5.x Equipment mounting

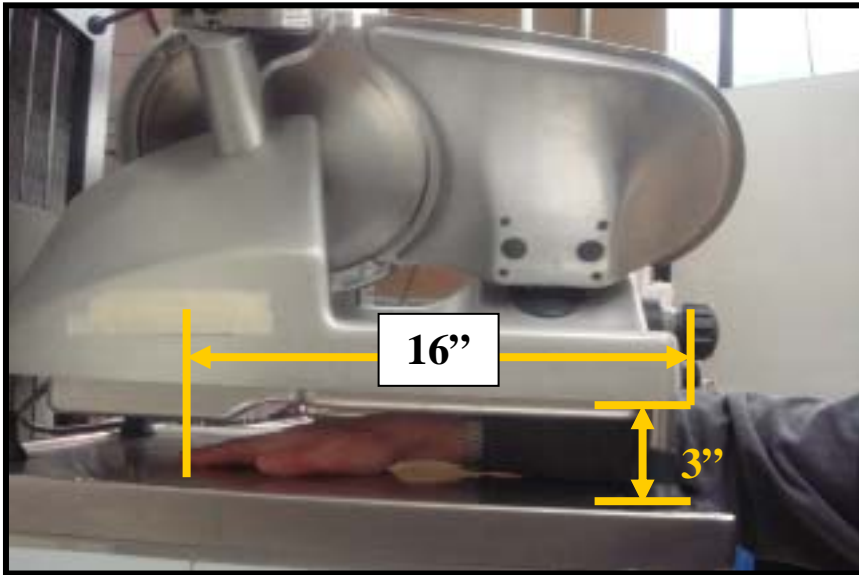
Pictured is the reach I attained under the current 3" clearance specification. I came of 4" short of the 20" standard.

Installation: NSF standards do not address equipment installations. It is the responsibility of the end user and local BOH's to install in a manor that provides cleanability. In this application, installation needs to allow accessibility from multiple sides.

Ergonomics: What is the average circumference and length of the human fore arm?

Participation: It would be helpful if other Task Group Members conducted a similar demonstration as the one pictured above to see what their reach potential is.

5.x.2 Counter-mounted equipment shall be designed and manufactured to be:

- portable; or
- sealed to the counter; or
- elevated on legs that provide a minimum unobstructed clearance beneath the unit of 4.0 in (100 mm); or
- elevated on legs that provide a minimum unobstructed clearance beneath the unit of 3.0 in (76 mm) provided that no part of the counter top under the unit is more than 20 in (508 mm) from the point of cleaning access; or
- elevated on legs that provide a minimum unobstructed clearance beneath the unit of 2.0 in (50 mm) provided that no part of the counter top under the unit is more than 3.0 in (76 mm) from the point of cleaning access
